**Our Ref:** 16015 DPIE RFI Response Letter Huntlee MOD 14 5-11-2021  
**Via:** email

**RE: HUNTLEE - STAGE 1 DEVELOPMENT-14 (MP 10\_0137 MOD 14)**

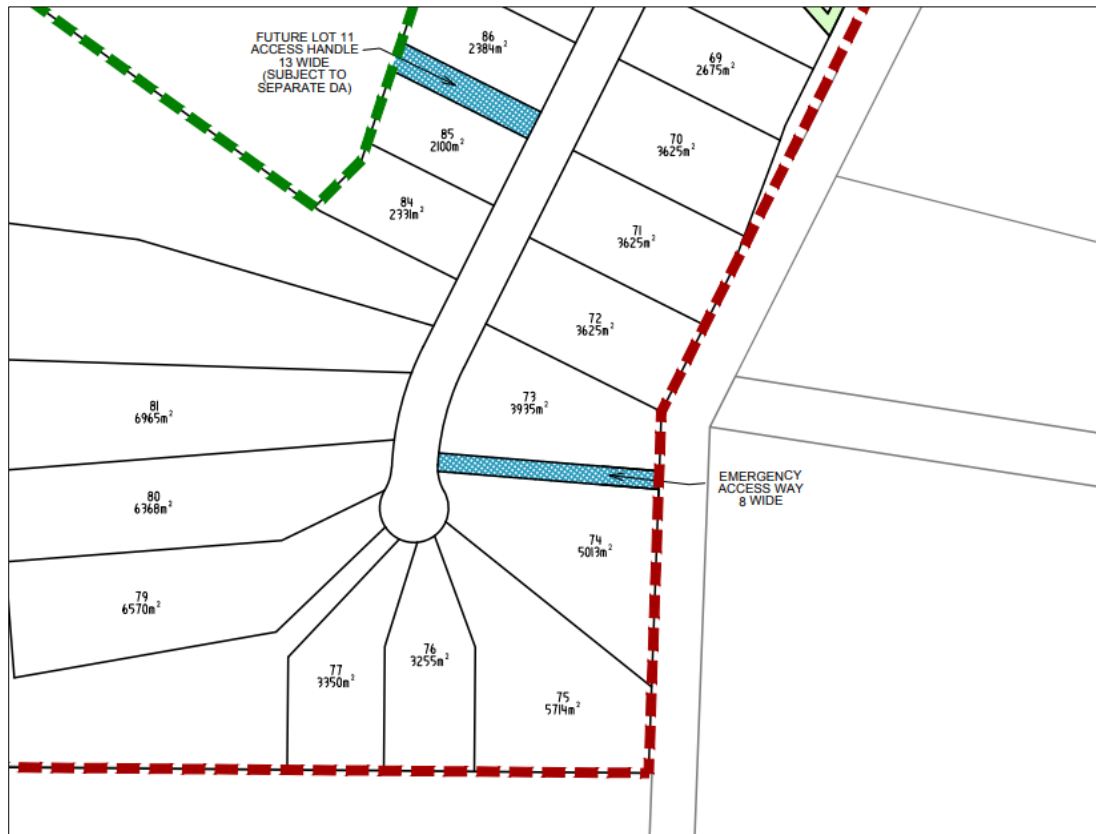
*Item 1 - confirmation from an accredited Bushfire Consultant that the emergency access to the south meets the requirements of Table 5.3b of Planning for Bushfire Protection 2019.*

The proposed emergency access to the south is shown on the base plan as being 8m in width (refer to inset below). A compliant road is able to be constructed in this allocation that adheres to the required 5.5m kerb to kerb carriageway width, grade, vertical clearance and load provisions. No parking will be available in the emergency road allocation. Provision of a reticulated water supply including hydrants have been provided in the subdivision arrangement.

On this basis the emergency access to the south is considered to meet the Table 5.3b requirements as set out in PBP (2019).
